# PRELIMINARY DRAINAGE PLAN PUD/SP 22-X

## HILLSIDE AT LORSON RANCH

**JANUARY, 2022**

# THE HILLS AT LORSON RANCH

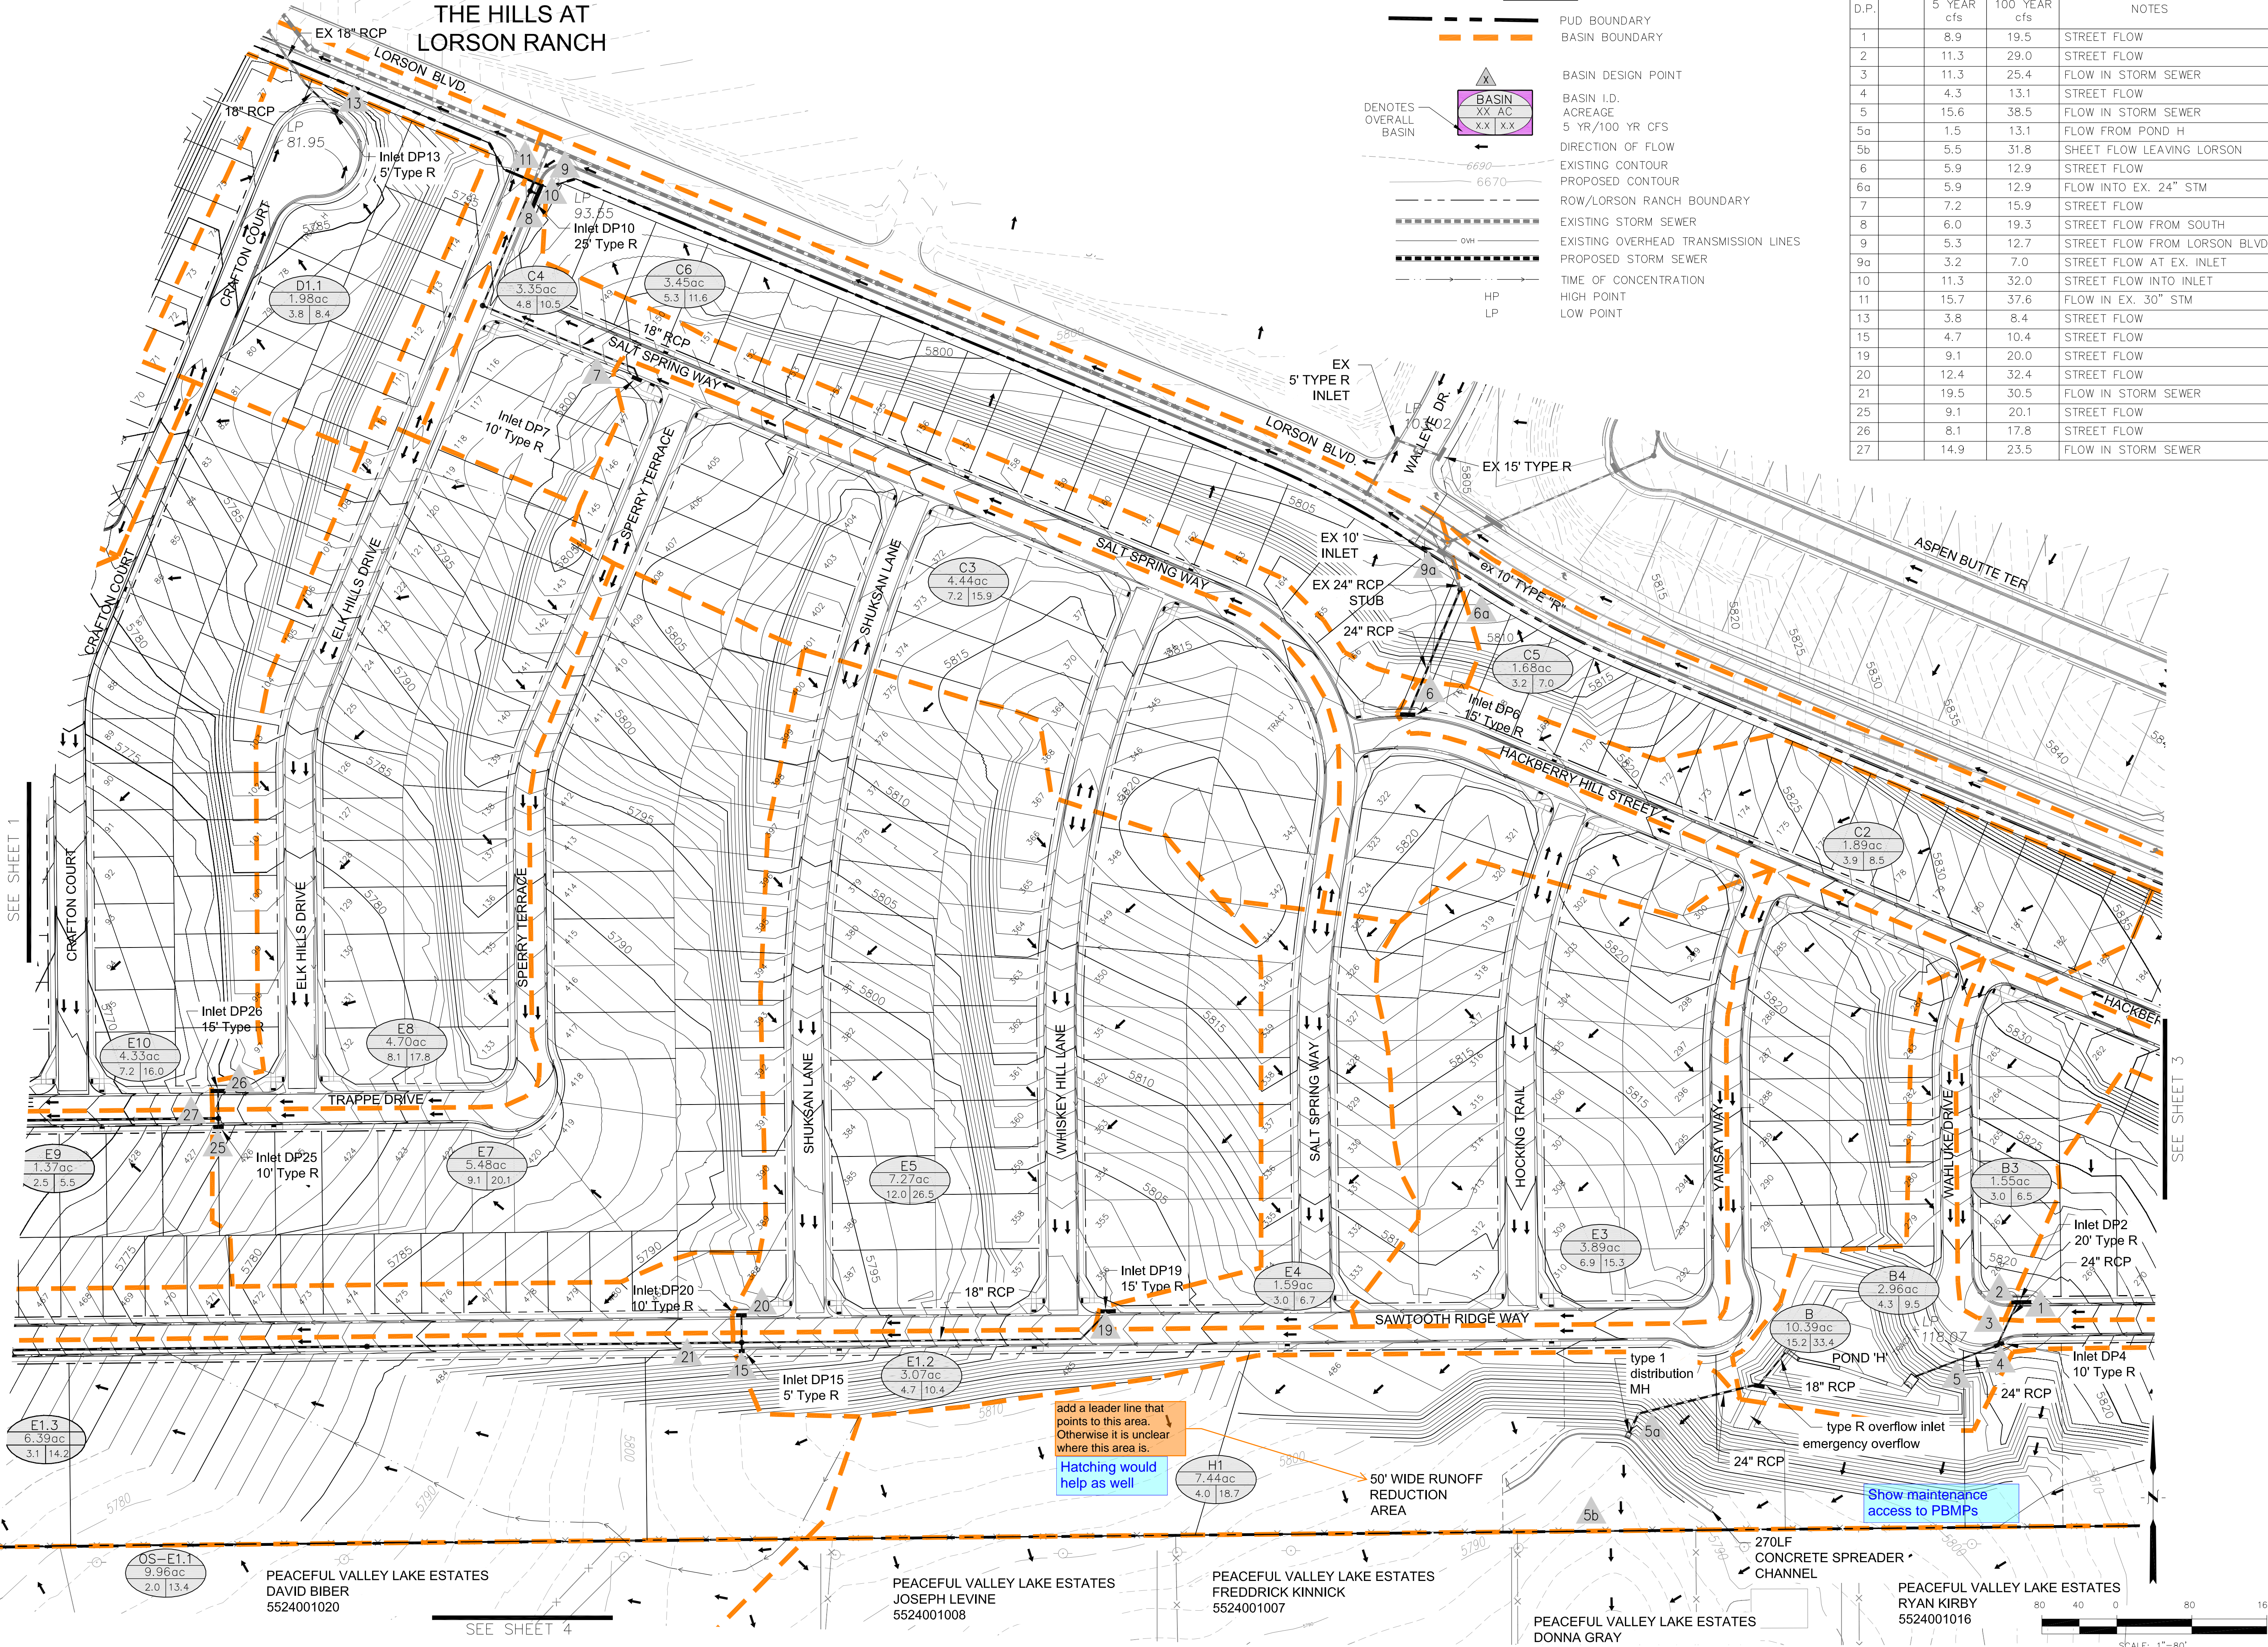
add a leader line that points to this area. Otherwise it is unclear where this area is.

Show maintenance access to PBMPs

DEVELOPED CONDITIONS  
HILLSIDE AT LORSON RANCH  
X

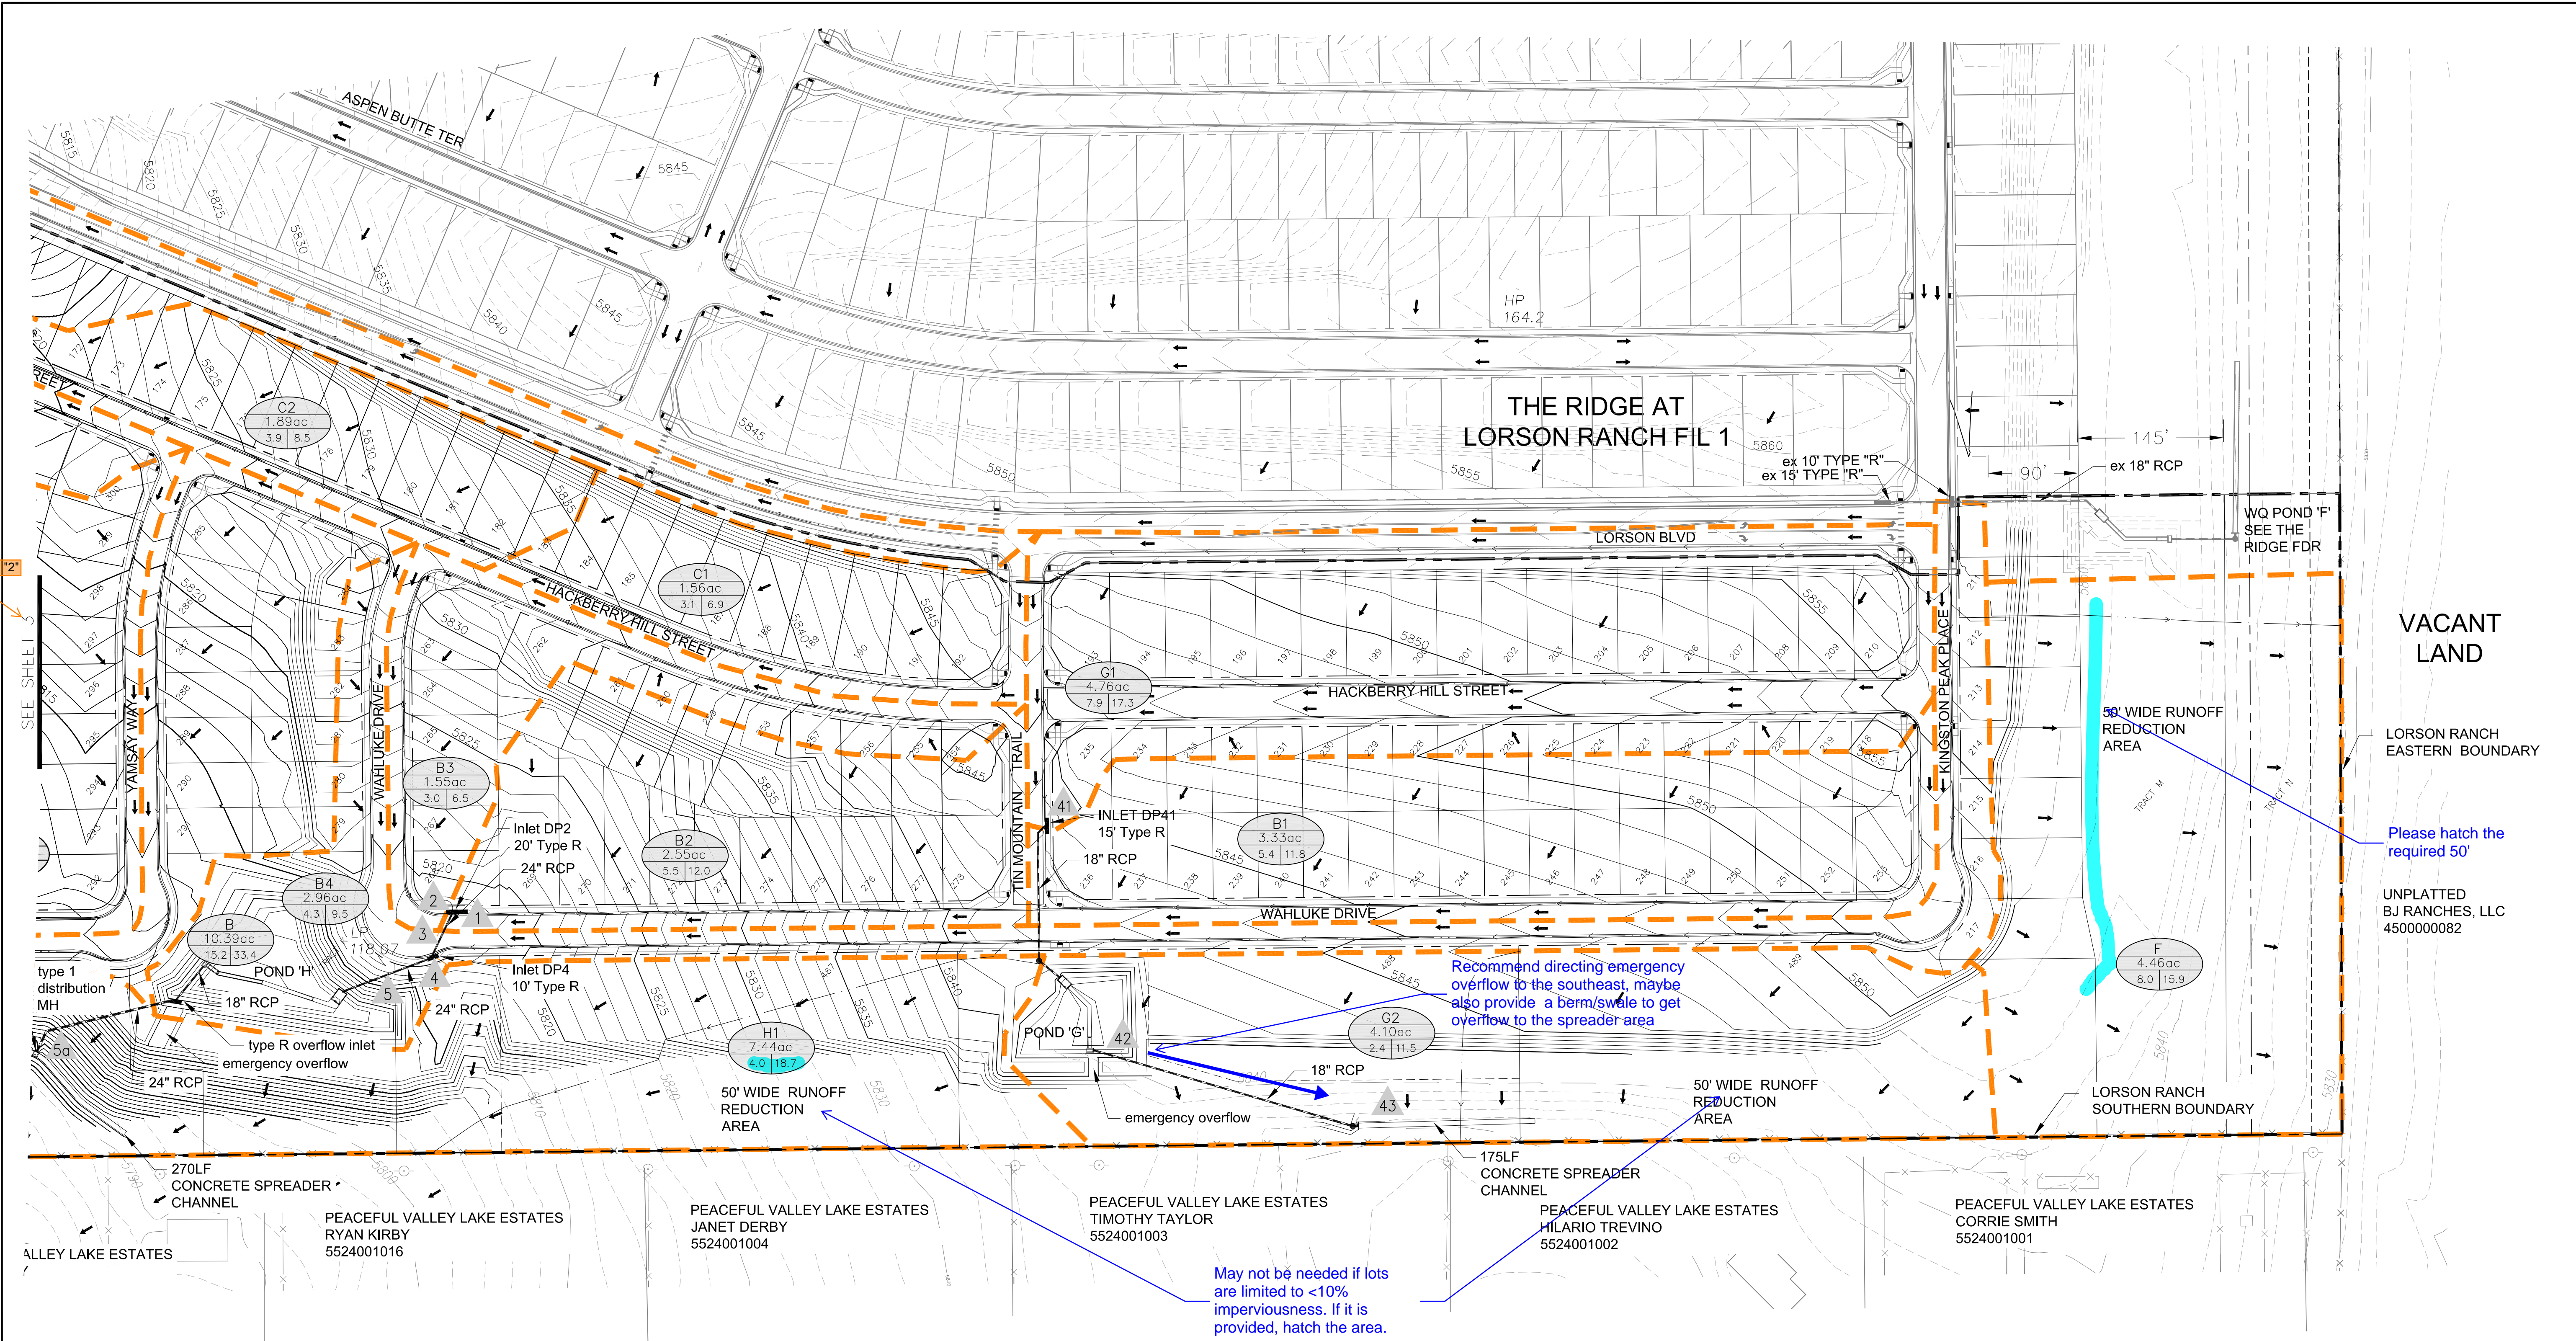
revise to "2"

Show maintenance access to PBMPs

May not be needed if lots are limited to <10% imperviousness. If it is provided, hatch the area.

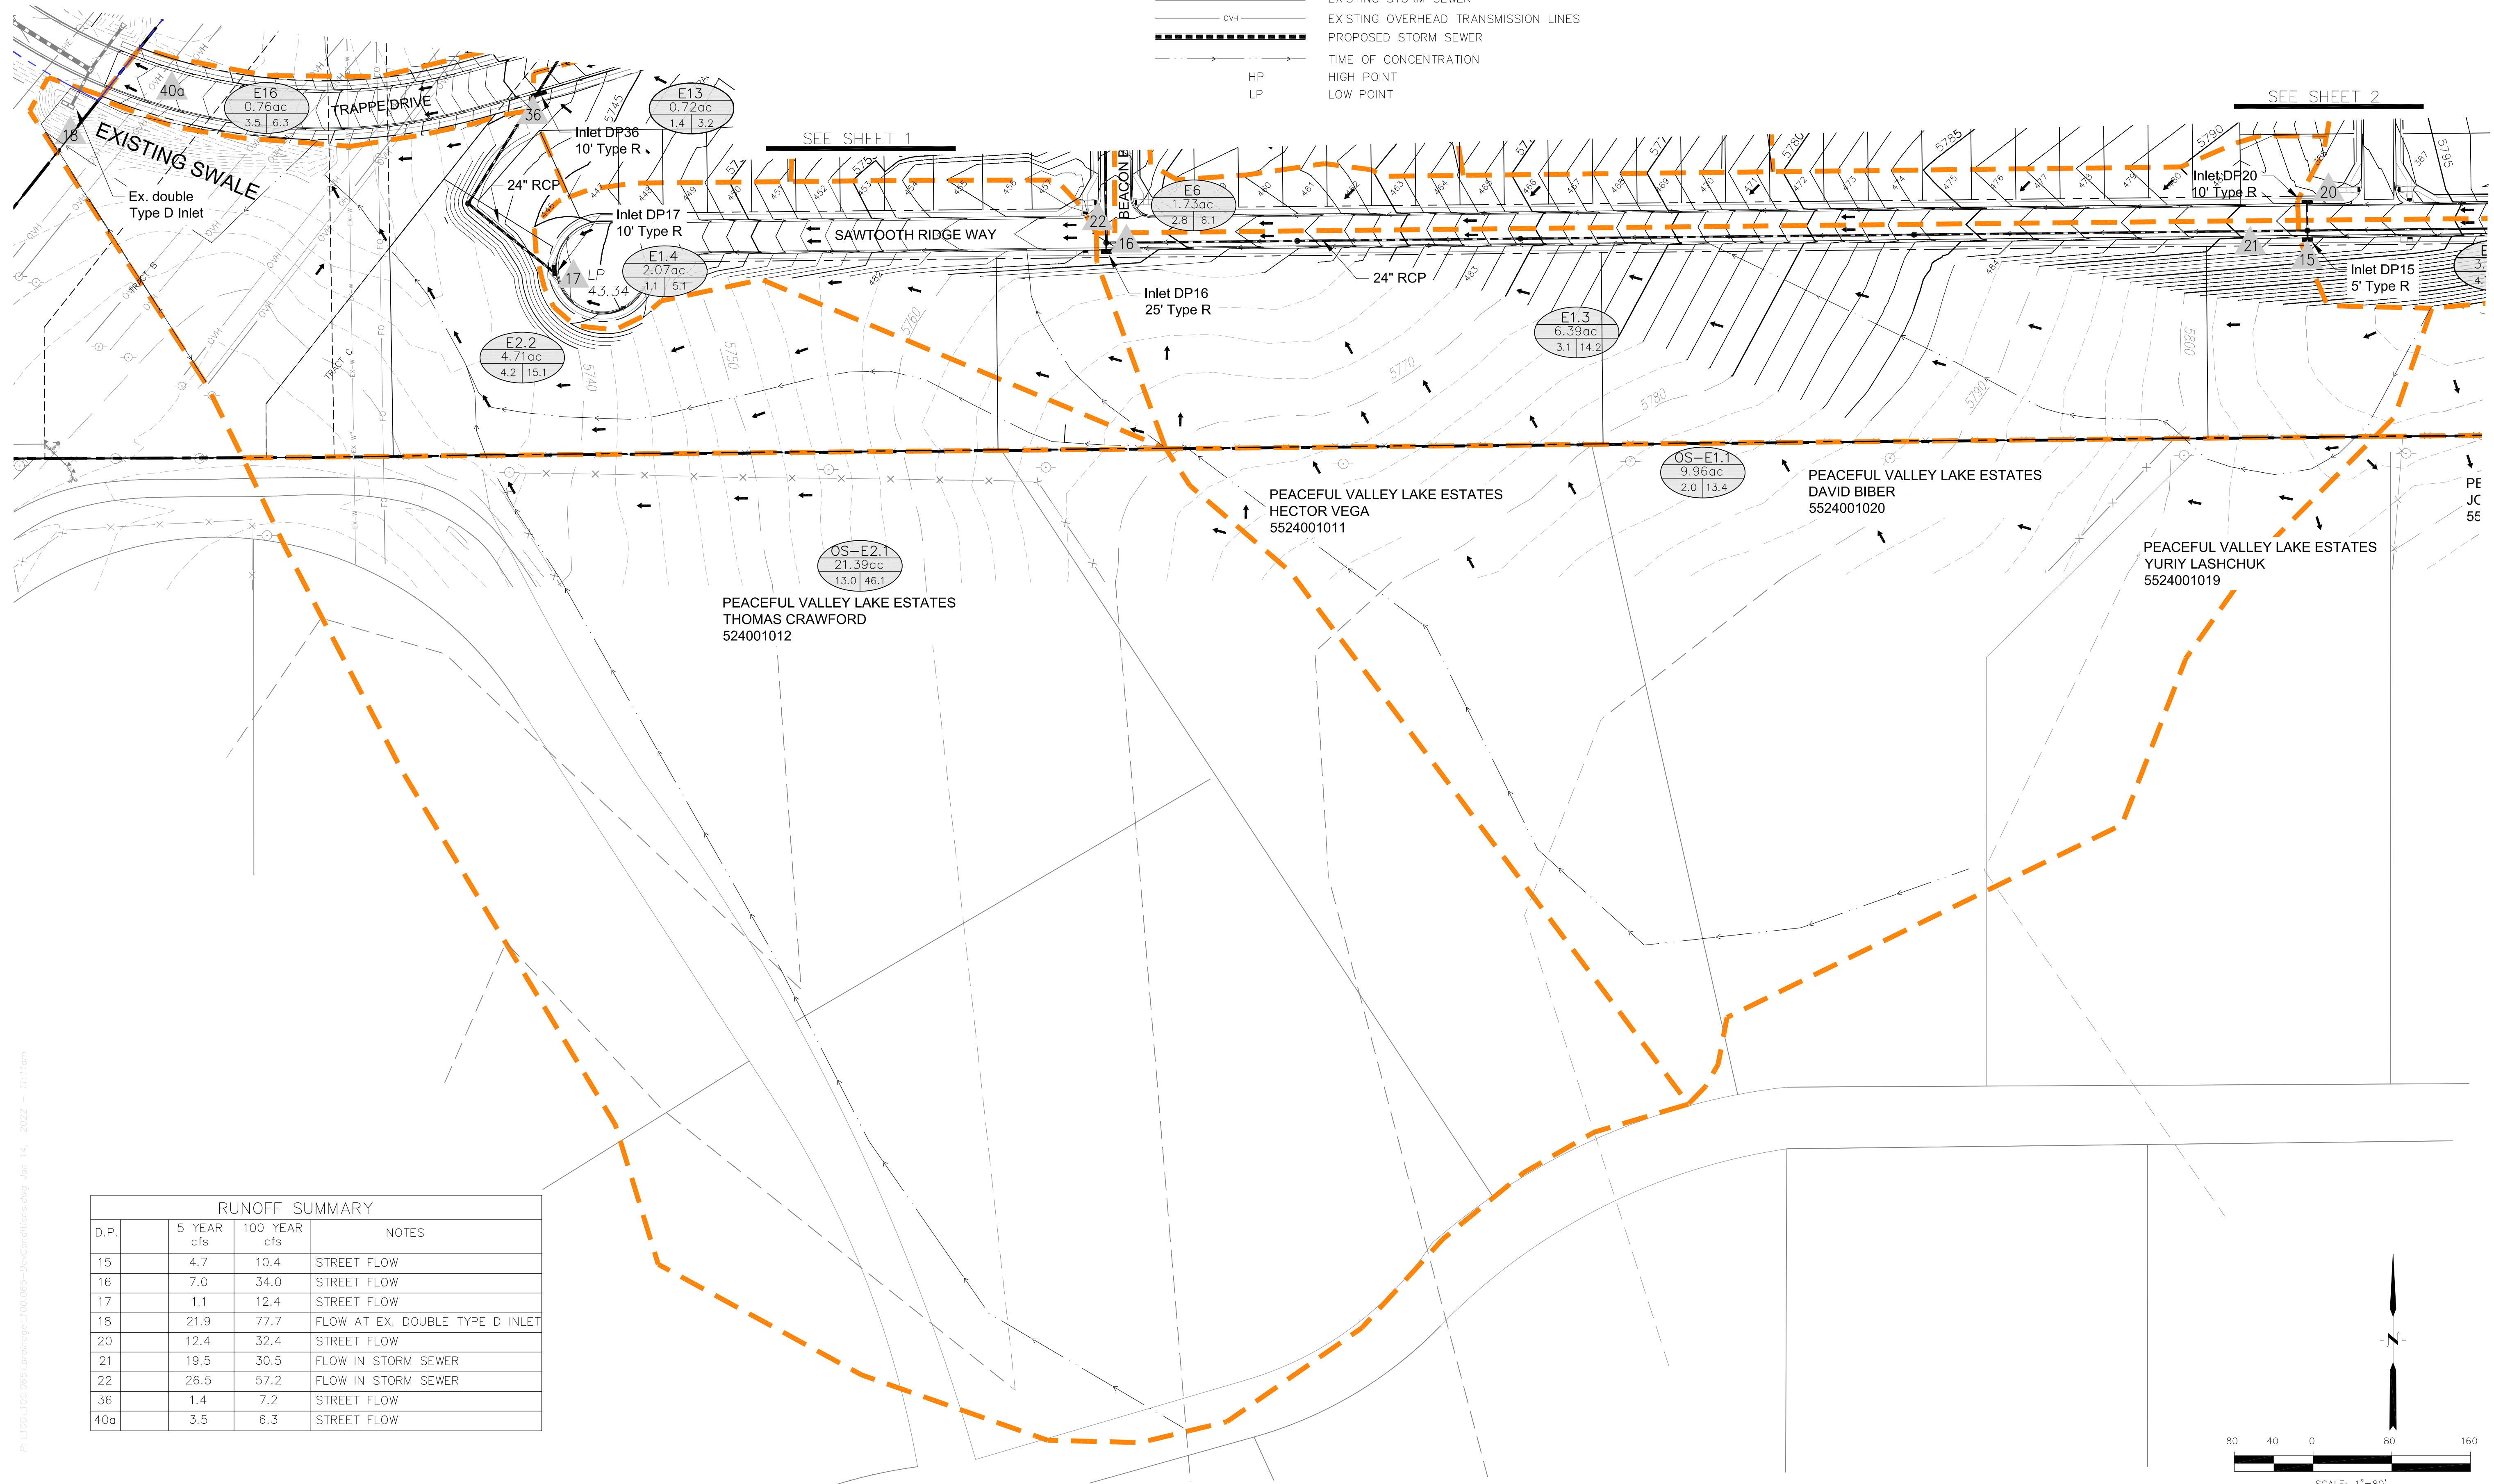
Recommend directing emergency overflow to the southeast, maybe also provide a berm/swale to get overflow to the spreader area

Please hatch the required 50'
